From: [James McFadden](#)
To: [Scanlon, Amy](#)
Subject: Milwaukee Road Depot
Date: Wednesday, March 01, 2017 1:44:39 PM
Attachments: [Washington Market Enclosure Detail 02.21.17.pdf](#)
[ATT00001.htm](#)
[Washington Market Landmarks 02.26.17.pdf](#)
[ATT00002.htm](#)

Enclosure Detail @ 1/2" = 1'-0"
 The Washington Market
 640 West Washington Avenue
 February 21, 2017

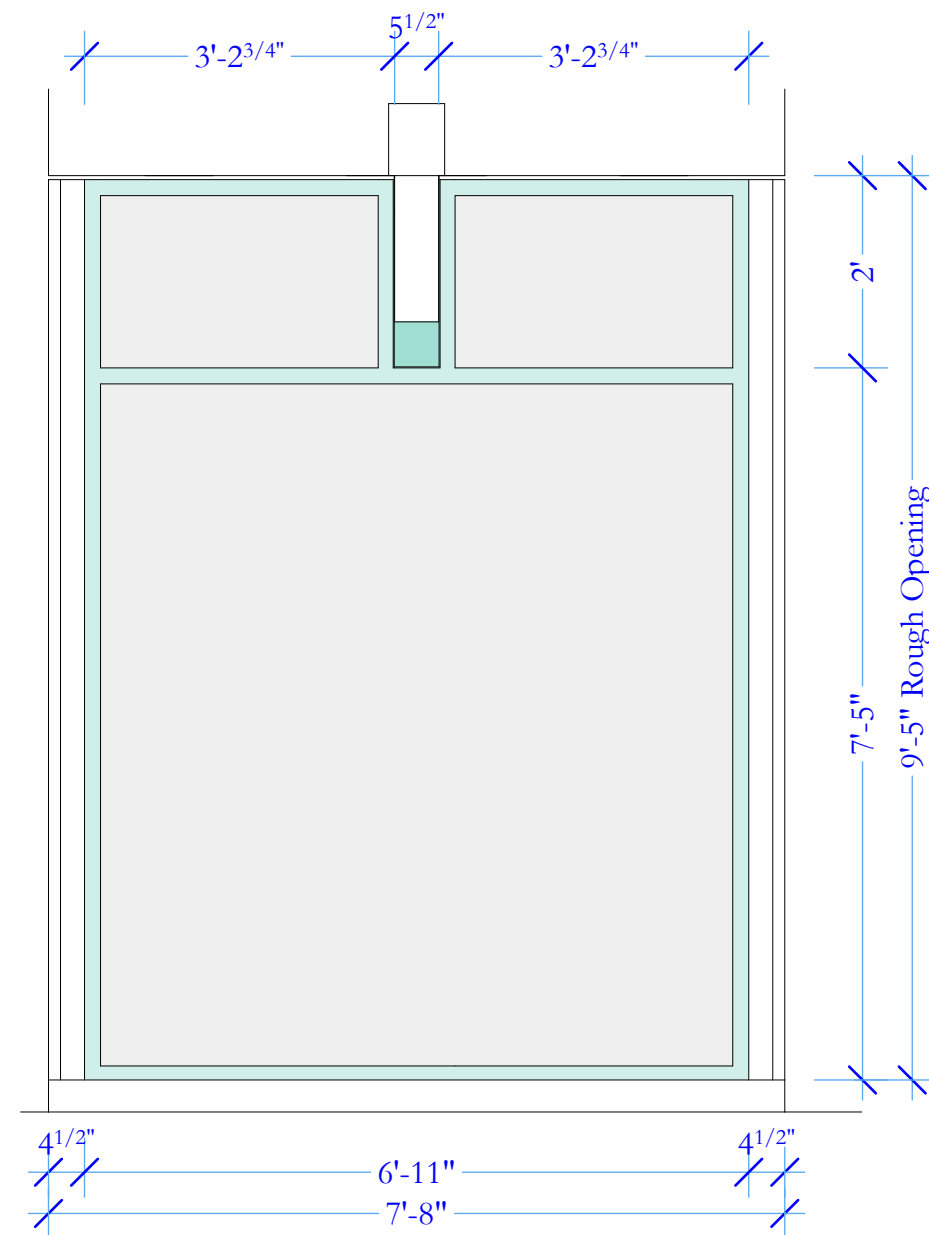
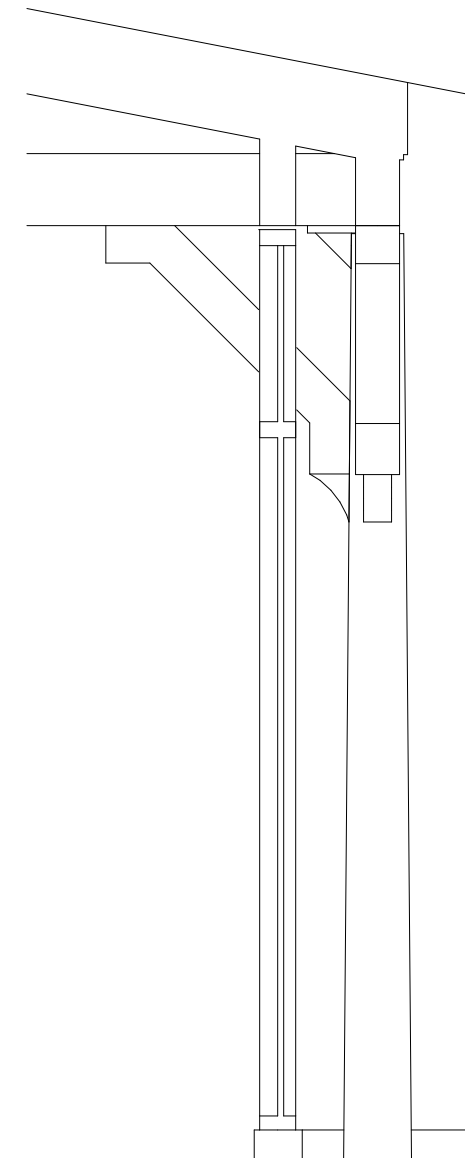
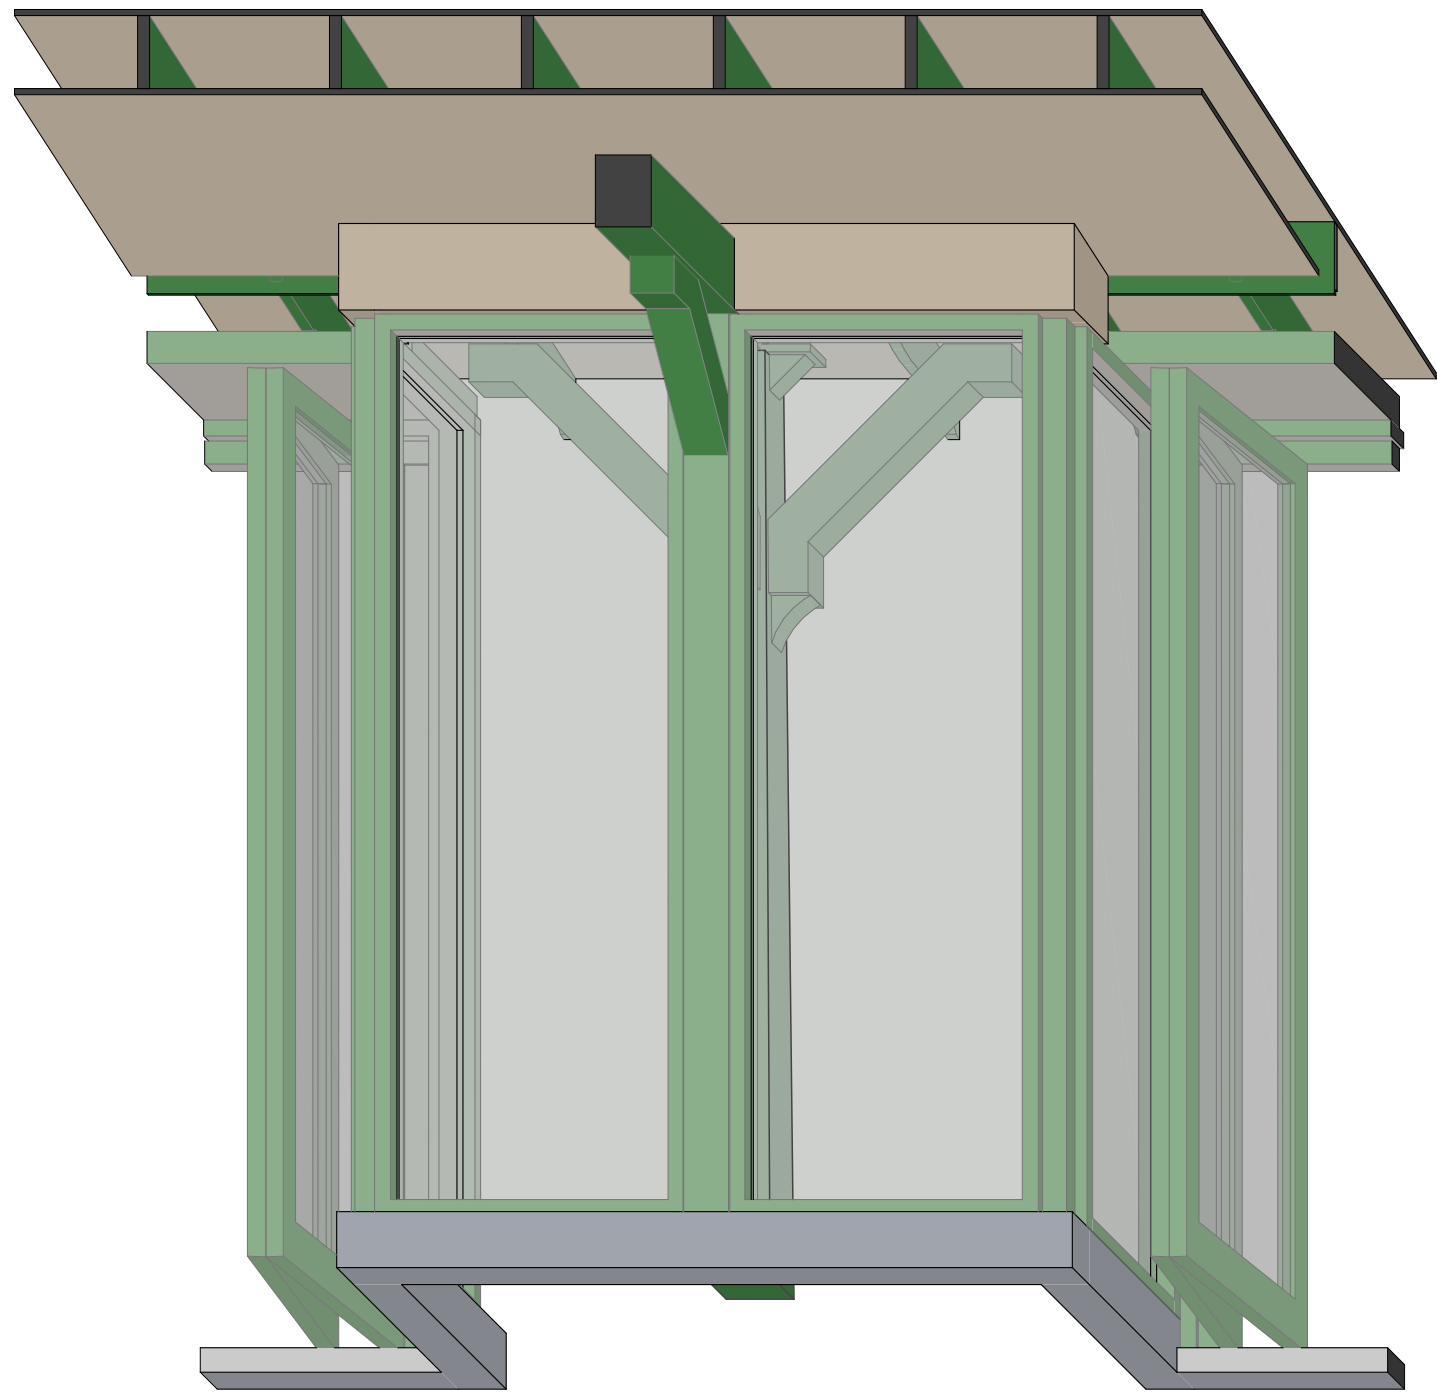
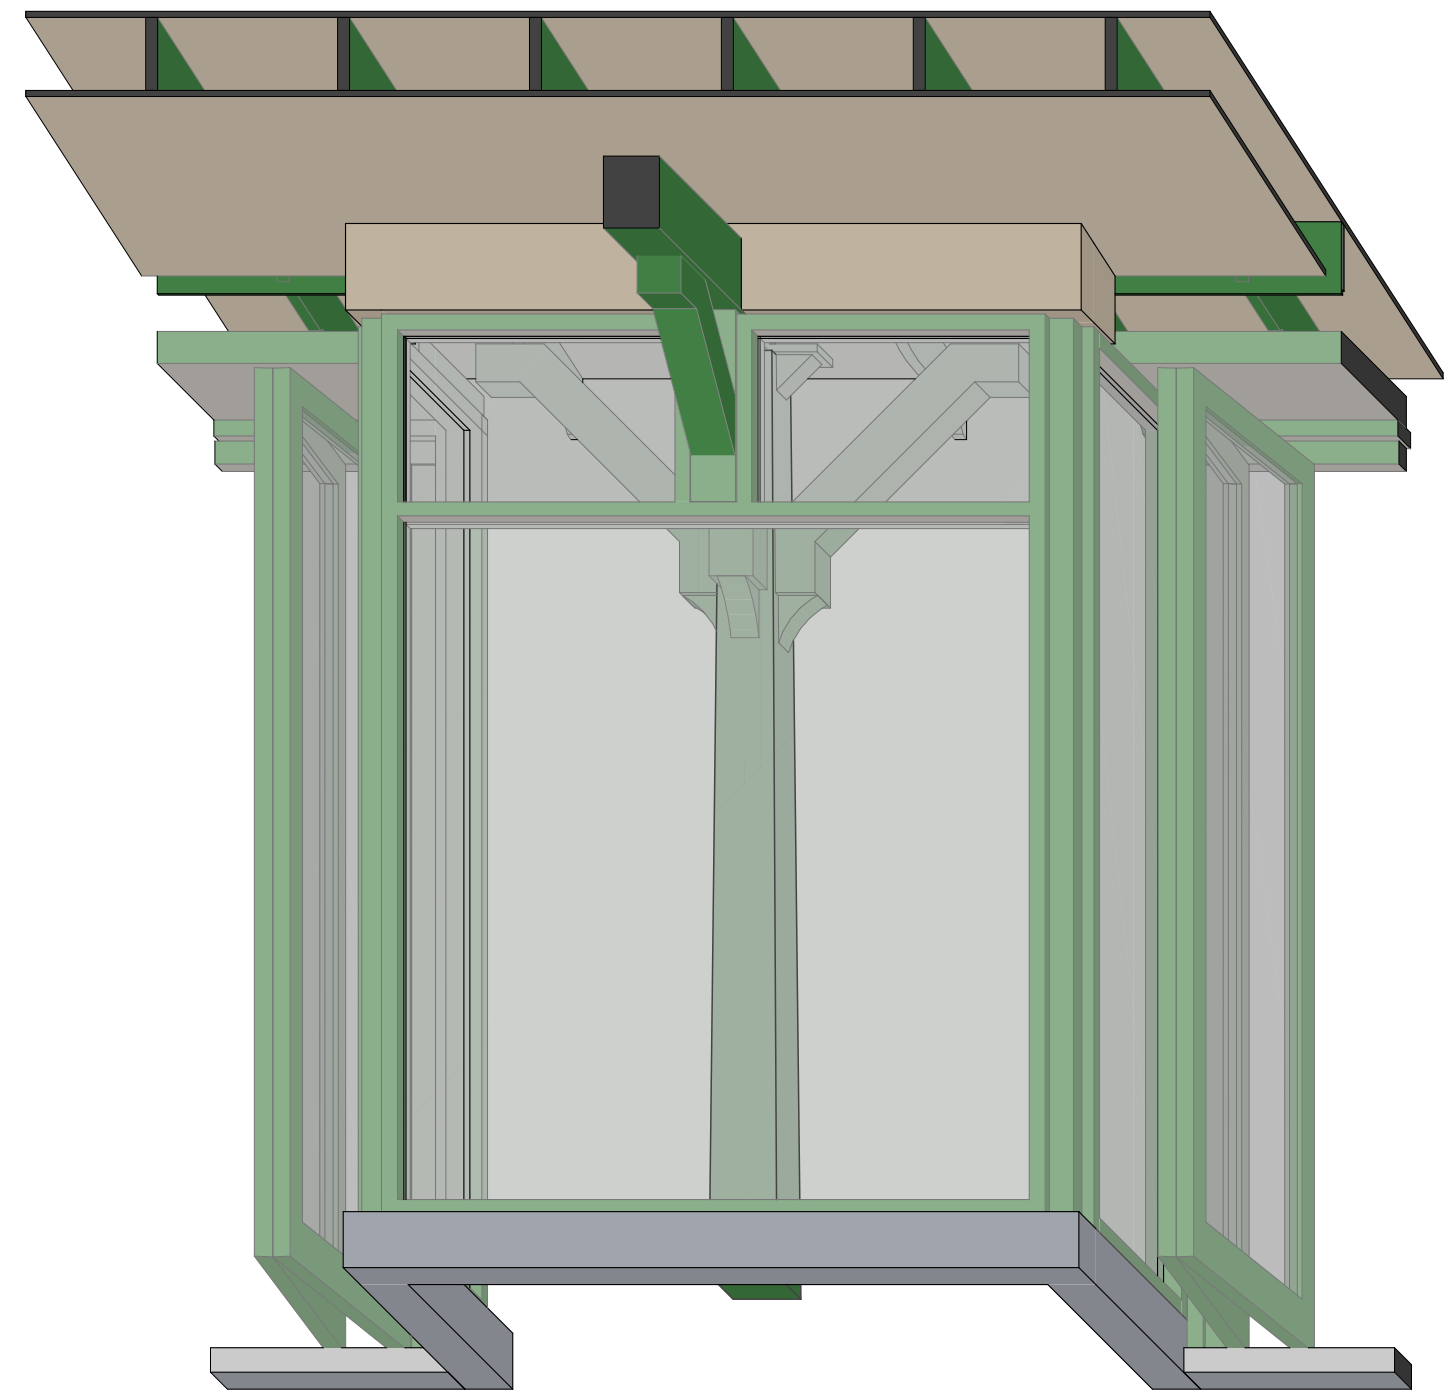
5. The platform enclosure has been reworked a bit at the columns. Originally the thought was to simply copy the approach utilized in the bike shop which is to place a new column behind each original one with glazing dying into each side. This looks fine in a frontal elevation but detracts from the view of the original column in fact. (See Washington Market Enclosure)
